Appliance Standards Awareness Project  
Natural Resources Defense Council

**RE: Docket Number EERE–2014–BT–STD–0058/RIN 1904–AD99: Notice of Webinar and Availability of Preliminary Technical Support Document for Clothes Dryers**

**Figure 1. Total volumes of the ENERGY STAR certified vented electric standard dryers with drum volumes of 7.3 or 7.4 cu. ft.<sup>12</sup>**

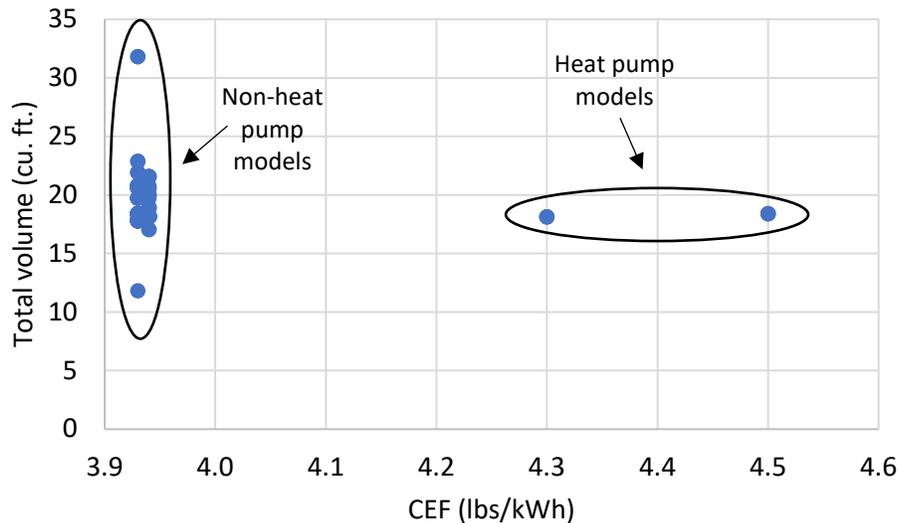
**We encourage DOE to reevaluate the assumption of increased installation costs for heat pump dryers.** For the preliminary analysis, DOE assumed that one-half hours of additional labor hours would be required for heat pump clothes dryers due to their larger dimensions relative to conventional dryers.<sup>11</sup> However, it does not appear that heat pump dryers in fact have larger dimensions than conventional dryers. For vented electric standard dryers, the available heat pump models have drum sizes of either 7.3 or 7.4 cu. ft. Figure 1 below shows the total volumes (height times width times depth) of the 187 ENERGY STAR certified models of vented electric standard dryers that have drum sizes of either 7.3 or 7.4 cu. ft. Most of the non-heat pump models have total volumes between 17 and 23 cu. ft., while the heat pump models have total volumes of either 18.1 or 18.4 cu. ft.

Of the 43 Whirlpool ENERGY STAR certified models of vented standard electric dryers with drum sizes of 7.4 cu. ft., 41 are listed with identical heights, widths, and depths of 38 in., 27 in., and 31 in., respectively, including the two heat pump models. The other two models, which have one larger dimension—a height of 42.5 in.—are not heat pumps. Of the 21 LG ENERGY STAR certified models of vented standard electric dryers with drum volumes of 7.3 cu. ft., the two heat pump models have

dimensions of 38.69 in., 27 in., and 30 in. for height, width, and depth, respectively, for a total volume of 18.1 cu. ft. All but one of the remaining models have dimensions of 40.19 in., 27 in., and 28.94 in. for a total volume of 18.2 cu. ft.<sup>13</sup>
